### Application For Alternate Material, Design, or Method of Construction Deviation Request Per 2019 Development Standards Section 1.5

The request is to provide a 16' alley, conforming with the alley's current configuration. One note from engineering states that a 20' alley shall be provided, unless otherwise approved by the Fire Marshal. We have received the required approval from the Fire Marshal, and believe the project can proceed as requested, with a 16' alley.

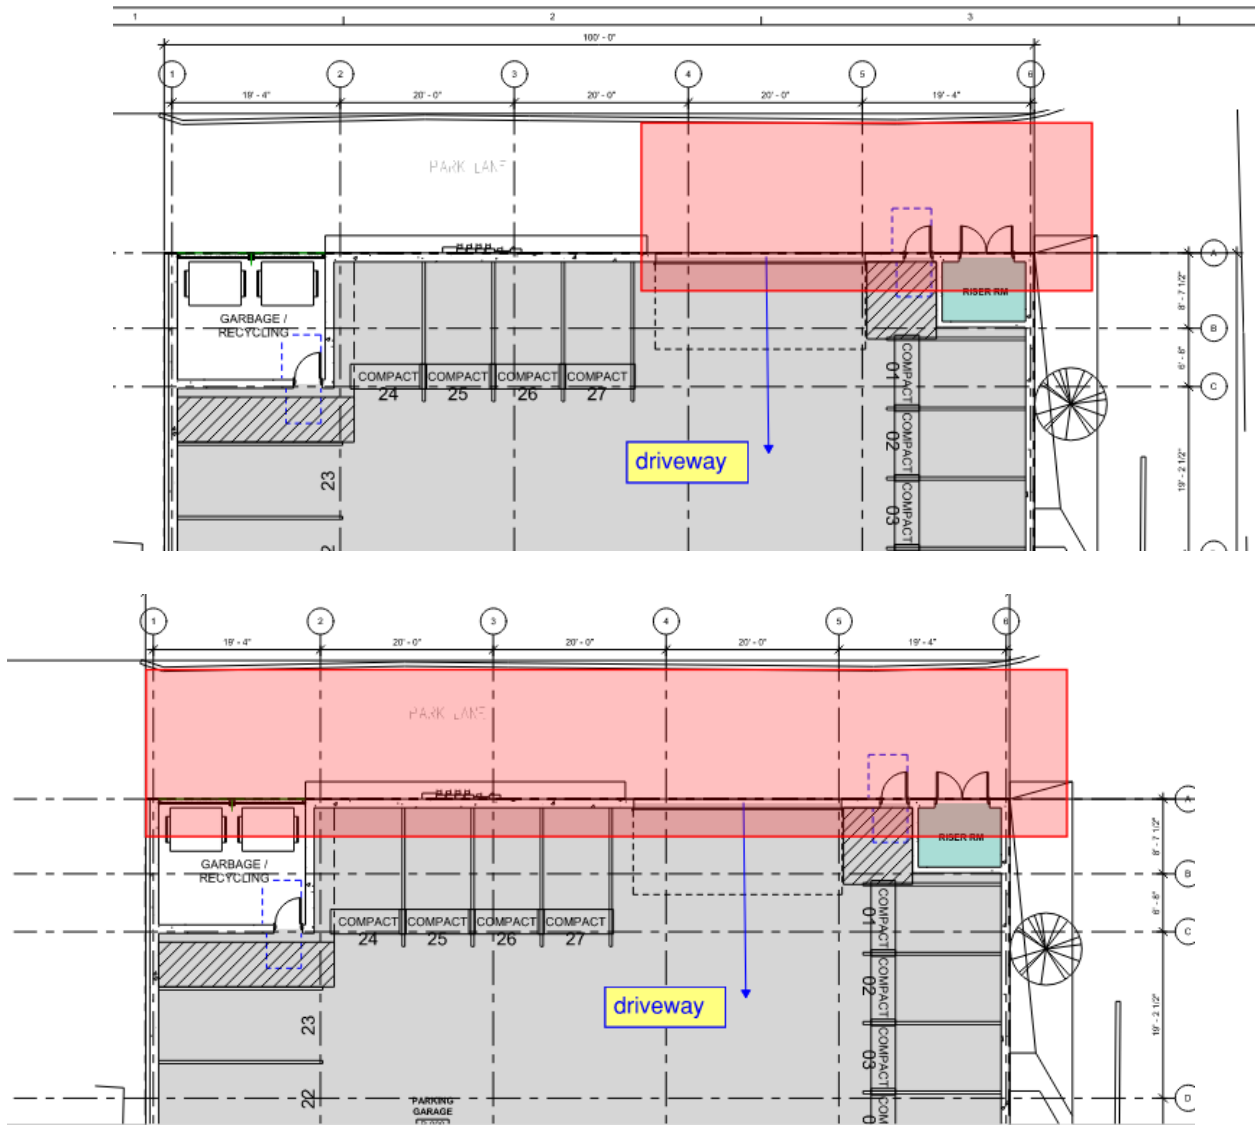
The existing alley has approximately 15' of pavement in a 16' wide right of way. The widened alley of 20' would encroach into the property quite a bit and make the parking garage difficult.

- 1) If the sprinkler system is provided as noted, is the existing width acceptable? **Yes, however the sprinkler system shall be a full NFPA 13 system, not 13R.**
- 2) If the width is increased, would you expect this additional width to be fully on our side, or split among both sides of the alley? (this one might be more for Brian). **Not sure how to answer this as the Fire Lane will belong to you and**

3) By driveway in your comment, do you mean going to the end of the driveable alley adjacent to the building, or to the end of the driveway into our garage? **Driveable alley.**

the maintenance of the fire lane will be the responsibility of the future homeowners or HOA. Separate owners for each side of the fire lane will require to be noted in the title agreement and this can be problematic.
